INSTRUCTIONS FOR INSTALLING THE 194245 MODIFICATION KIT
TO PROVIDE AN IMPROVED TAPE SUPPLY ARM FOR HIGH SPEED
REPERFORATOR TRANSMITTER TAPE HANDLING STAND LTHS207

a. The 194245 Modification Kit provides an improved tape supply arm which eliminates erratic operation of the tight-tape switch on the LTHS207.

FIGURE 1

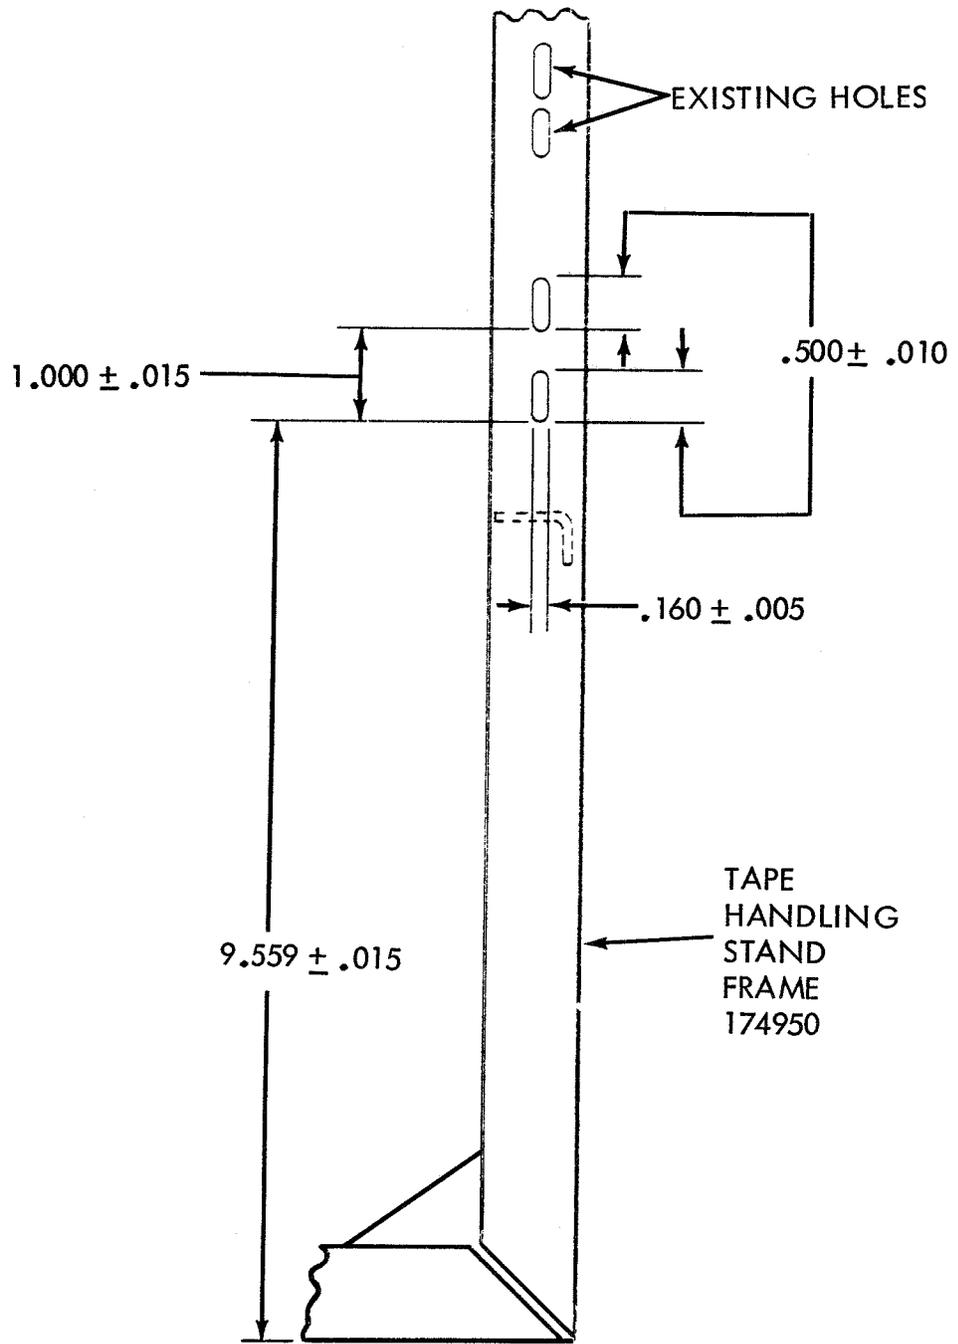
(3) Work over the 174950 Tape Handling Stand Frame by adding the two new mounting holes as per Figure 1.

FIGURE 2

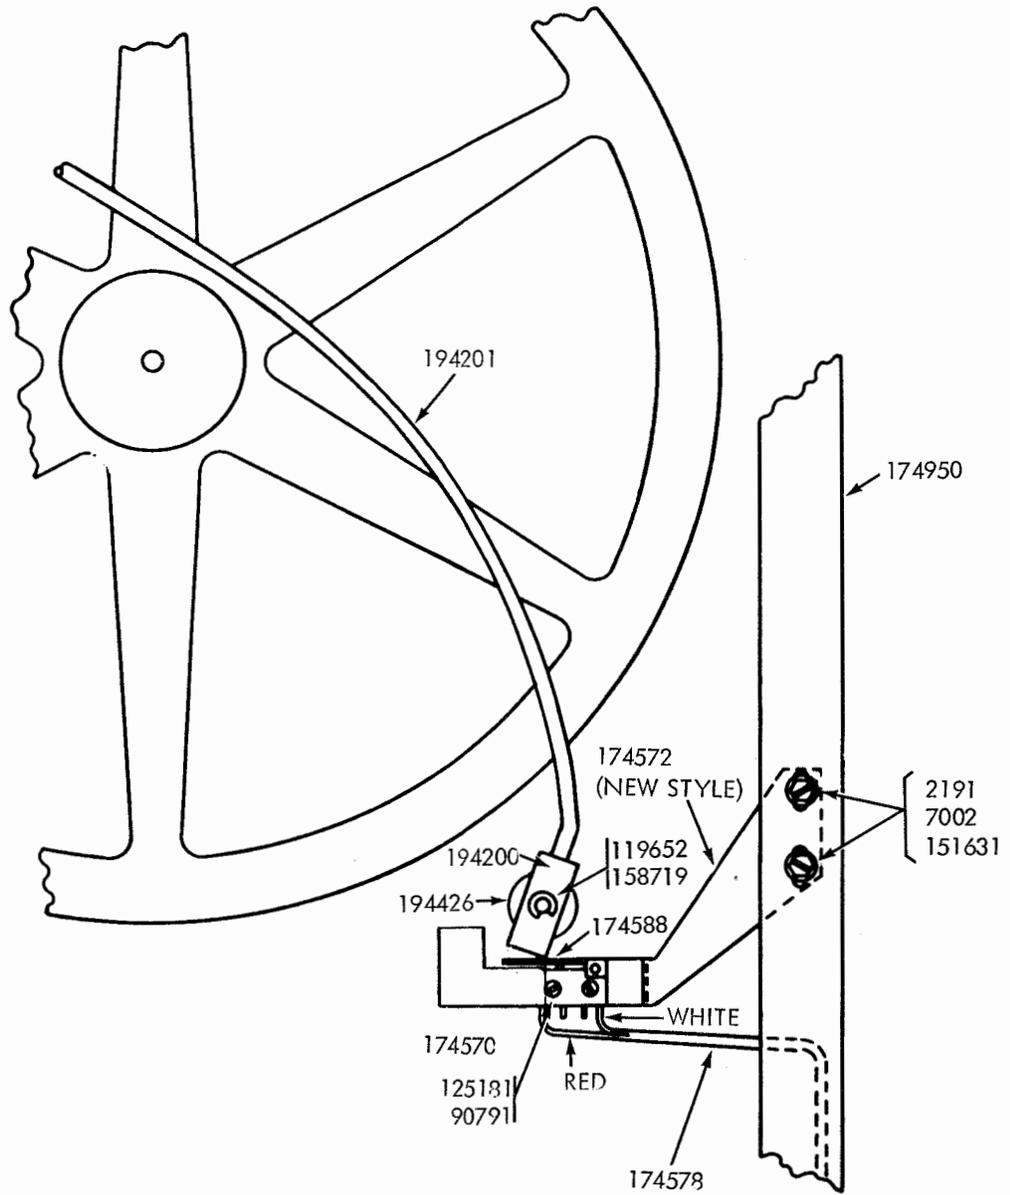
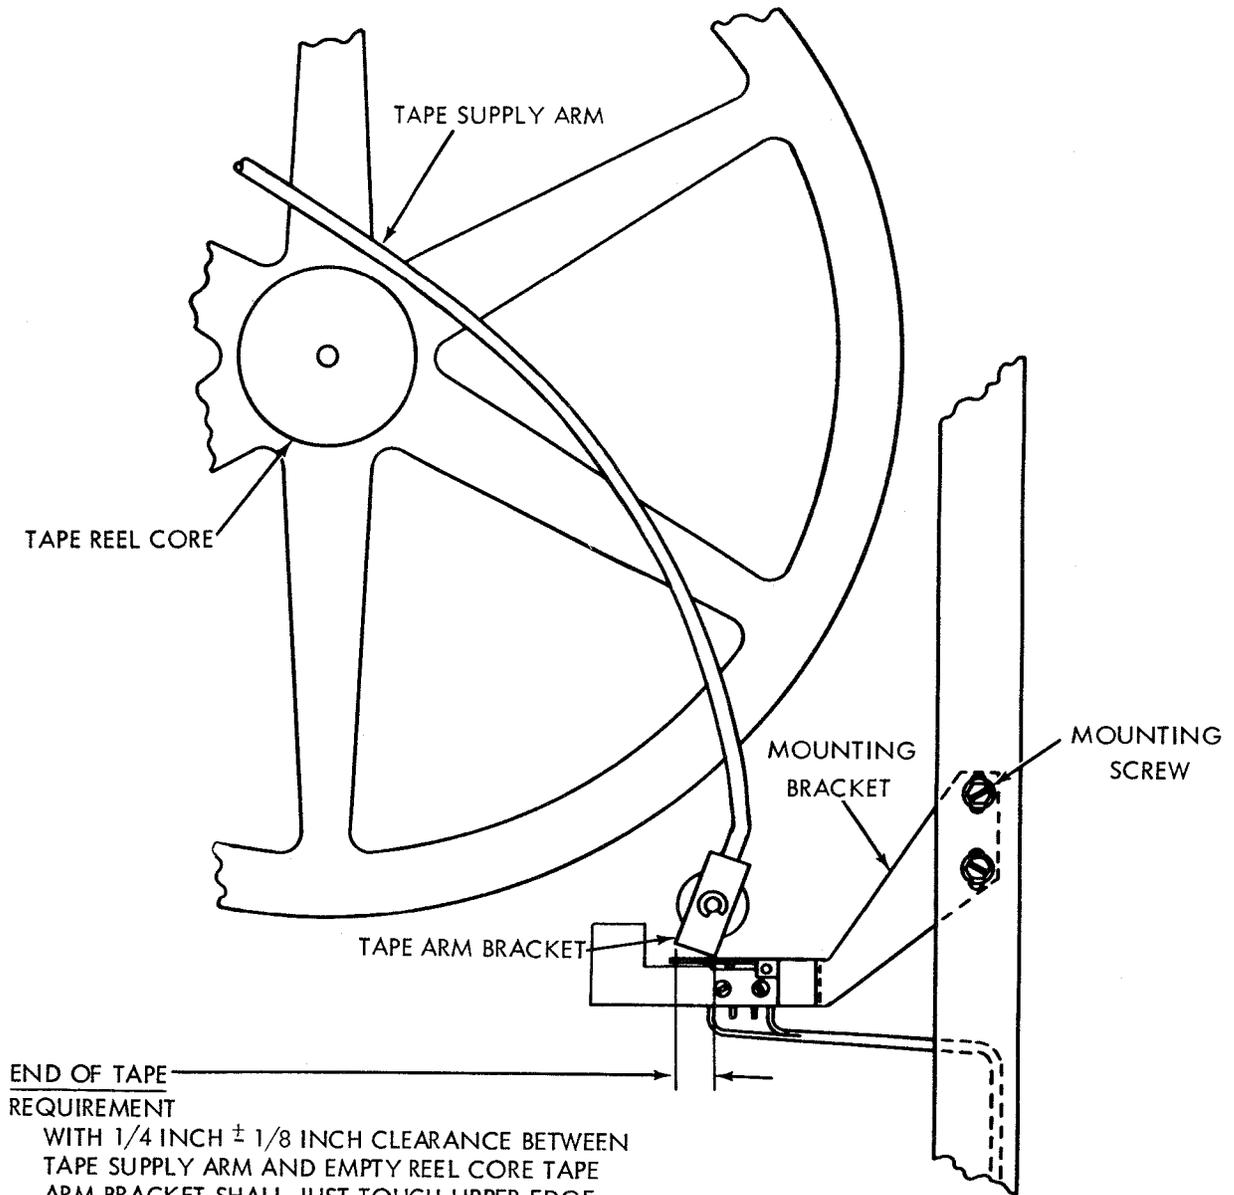
a. Remove the 158985 Tape Supply Arm.

b. Install the 194201 Tape Supply Arm.

(1) Assemble the 194201 Tape Supply Arm on the 159214 Support Bracket with the two 119652 Ring Retainers retained in Paragraph a.(2), above.

(2) Assemble the 170836 Bracket to the 194201 Tape Supply Arm with the hardware retained in Paragraph a.(1), above.

(3) Assemble the 194200 Bracket to the 194201 Tape Supply Arm with the 2191 Lock Washer and 3606 Nut provided.

(4) Assemble the 158719 Shaft and 194426 Roller provided onto the 194200 Bracket with the two 119652 Retainer Rings retained in Paragraph a.(3), above.

FIGURE 4

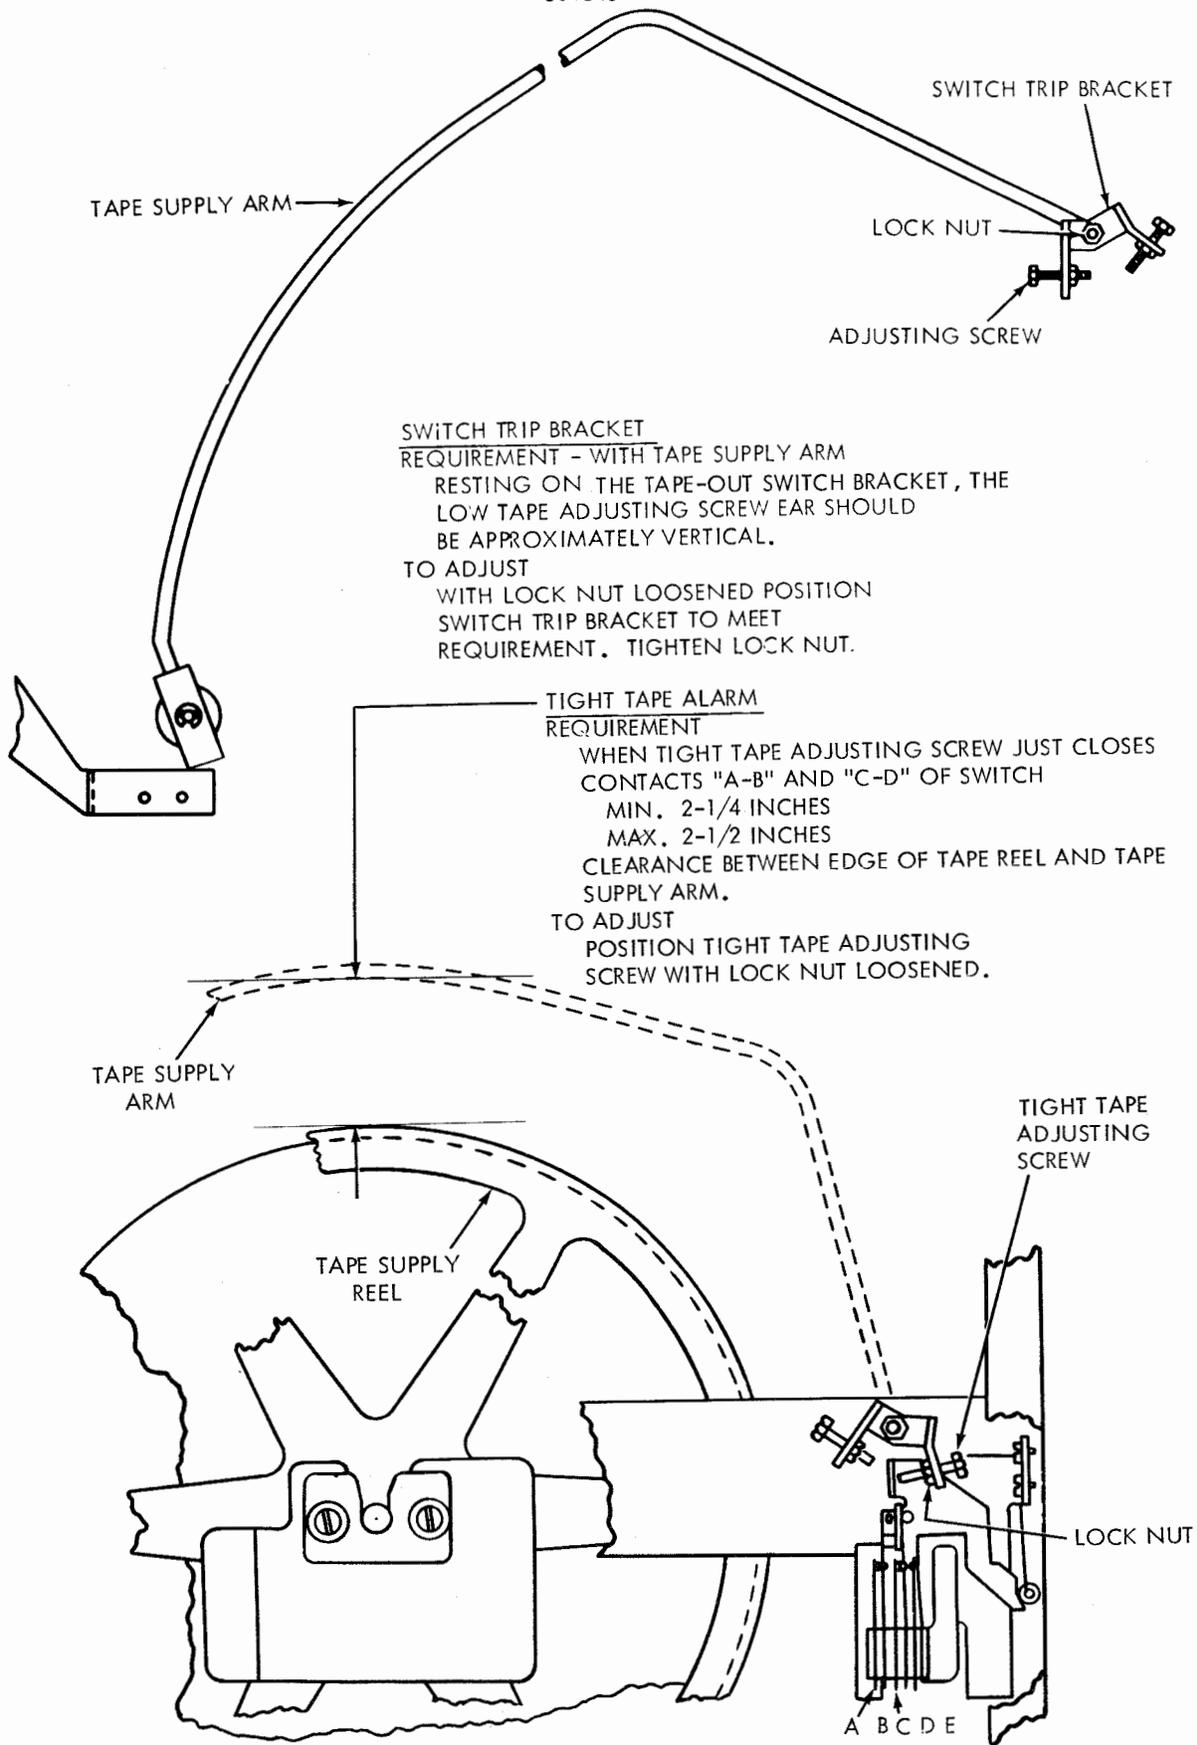
LOW TAPE ALARM**REQUIREMENT**

WHEN LOW TAPE ADJUSTING SCREW JUST CLOSSES CONTACTS
"D-E" THROUGH DETENT ACTION (ROLLER ON PEAK OF DE-
TENT LEVER CAMMING SURFACE)

MIN. 1/2 INCH

MAX. 1-1/4 INCH

CLEARANCE BETWEEN EMPTY TAPE REEL CORE AND
TAPE SUPPLY ARM.

TO ADJUST
POSITION LOW TAPE ADJUST-
ING SCREW WITH LOCK NUT
LOOSENED.
